TECHNICAL ALERT

TA03 4401

Discovery Series II: Correct Installation of AT Selector Knob

Figure 1

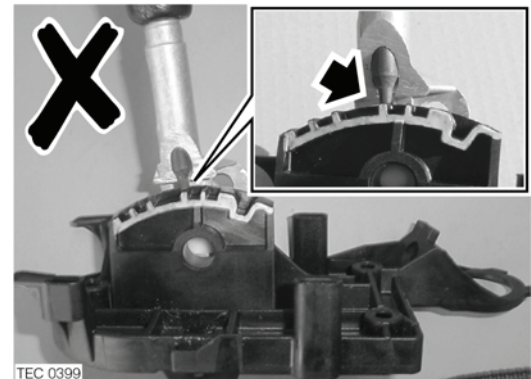
When fitting the automatic transmission selector knob after a service repair, the park release button rod can be damaged. The damage can result from incorrectly positioning the gear selector when the selector knob is fitted. (Figure 1)
